OIL CONSERVATION DIVISION
1220 South St. Francis Dr.
Santa Fe, NM 87505

<p>WELL API NO. 30-025-25830</p>	
<p>5. Indicate Type of Lease STATE <input checked="" type="checkbox"/> FEE <input type="checkbox"/></p>	
<p>6. State Oil & Gas Lease No. E-1186</p>	
<p>7. Lease Name or Unit Agreement Name PHILLIPS STATE</p>	
<p>8. Well Number 1-Y</p>	
<p>9. OGRID Number 024225</p>	
<p>10. Pool name or Wildcat KEMNITZ CISCO</p>	
<p>SUNDRY NOTICES AND REPORTS ON WELLS (DO NOT USE THIS FORM FOR PROPOSALS TO DRILL OR TO DEEPEN OR PLUG BACK TO A DIFFERENT RESERVOIR. USE "APPLICATION FOR PERMIT" (FORM C-101) FOR SUCH PROPOSALS.)</p>	
<p>1. Type of Well: Oil Well <input type="checkbox"/> Gas Well <input checked="" type="checkbox"/> Other</p>	
<p>2. Name of Operator W. A. MONCRIEF, JR.</p>	
<p>3. Address of Operator 950 COMMERCE, MONCRIEF BUILDING, FORT WORTH, TX 76102</p>	
<p>4. Well Location Unit Letter <u>I</u> : <u>1675</u> feet from the <u>SOUTH</u> line and <u>625</u> feet from the <u>EAST</u> line Section <u>8</u> Township <u>16S</u> Range <u>34E</u> NMPM <u>13</u> County <u>LEA</u></p>

P&A PROCEDURE:

Operator: W A MONCRIEF JR 950 Commerce Fort Worth, TX 76102	OGRID: 24225
	Action Number: 67

CURRENT WELLBORE SCHEMATIC

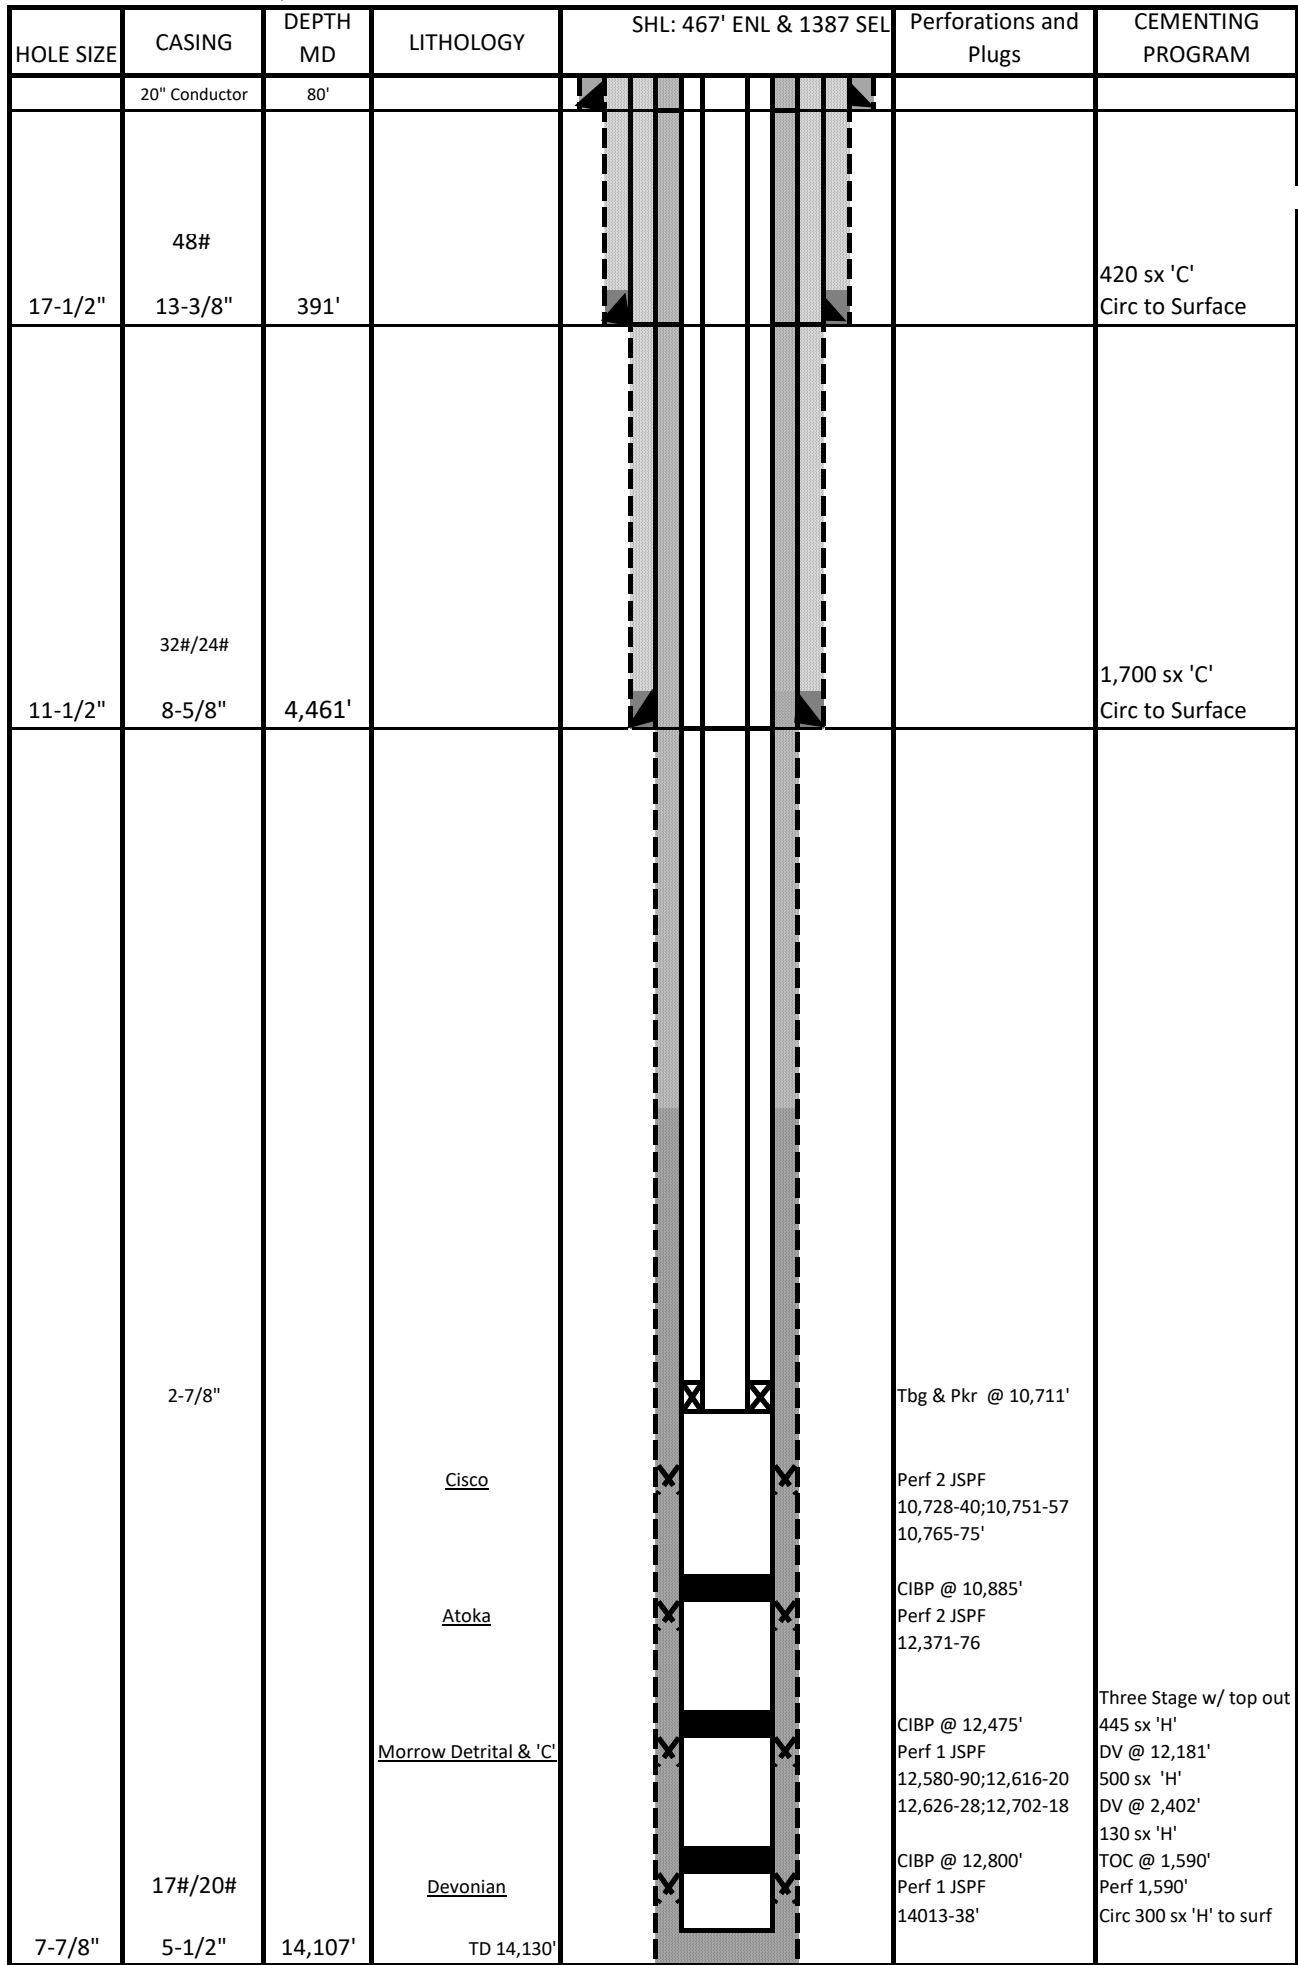
Note Changes to Procedure

POOH W/ RODS & TBG
GIH W TBG TO 10,700'. LD HOLE WITH 9# FLD. MIX 30 SX CLASS H CMT & SPOT.
WOC & TAG Pressure test casing Spot 25 sx Class H 9600 WOC & tag
POOH W/ TBG. GIH W/ WLINE PERF @ 8,000'. GIH W/ TBG & PKR. SQUEEZE PERFS W/ 40 SX WOC & tag
POOH W/ TBG. GIH & PERF @ 6,000'. GIH W/ TBG & SQUEEZE W/ 40 SX WOC & tag Spot 25 sx Class C 7300 WOC & tag
POOH W/ TBG. GIH & PERF @ 4,500'. GIH W/ TBG & SQUEEZE W/ 40 SX 50 sx Class C WOC & atg 4050 or higher
WOC & TAG
POOH TO 2,500' & SPO 25 SX Spot 25 sx Class C 1700 Top of Salt P&S 50 sx Class C 440 Csg shoe
POOH TO 100' CIRC CMT TO SURFACE 150' to surface
REMOVE ALL EQUIPMENT AND RECLAIM SURFACE LOCATION

Created By	Condition	Condition Date
kfortner	See attached conditions of approval Note changes to procedure	1/4/2022
